Environmental Review Team Report

Laurel Lane Subdivision

Columbia, Connecticut

March 1980

WATERSHEDS - STORM DRAINAGE SYSTEM, PLAN B

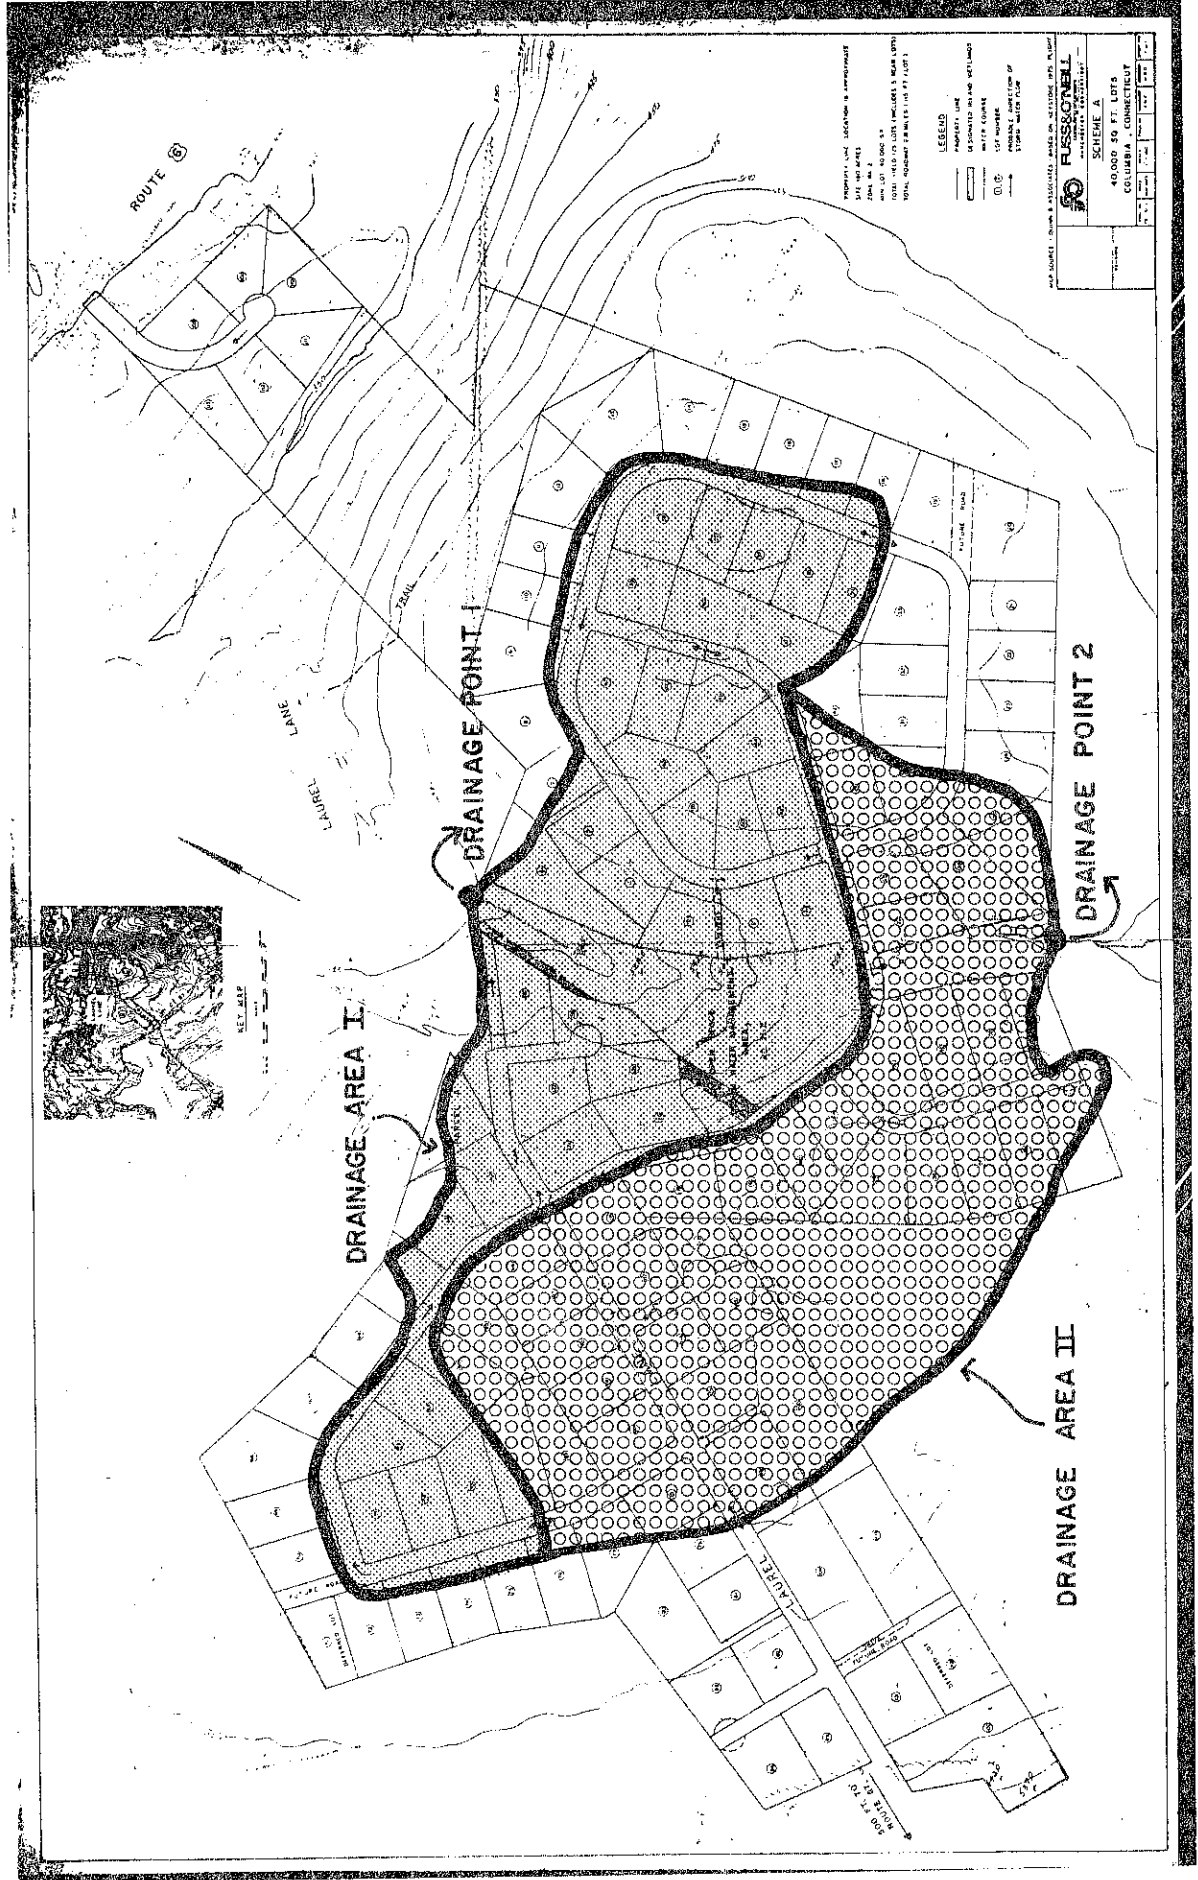
As the estimates above indicate, the proposed development may lead to substantial peak-flow percentage increases. In particular, with the suggested storm drainage system in place, discharges at Drainage Point 2 may be approximately six to nine times greater for a 10-year storm and four to six times greater for a 100-year storm than they are at present. These very large increases would result in part from the redirecting of drainage from many of the lots. The storm drainage system would also, in turn, reduce the percentage increase in runoff at Drainage Point 1 from that which would occur under developed conditions in the absence of such a system.

Another consideration with respect to subdivision drainage would be the amount of road salts that would be carried into the stormwater management areas. According to a study prepared by the U.S. Geological Survey, the town of Columbia applied an average of 4.7 tons of salt to each mile of town road during the winter of 1976-1977. Since slightly more than 2 miles of new subdivision roads would lie within the watershed of the management areas, it may be estimated that approximately 11 tons of salt may be dispersed through those areas.

used. In addition to retention basins, slope stabilization methods should be considered for those areas in the immediate vicinity of any piped-discharge outlet.
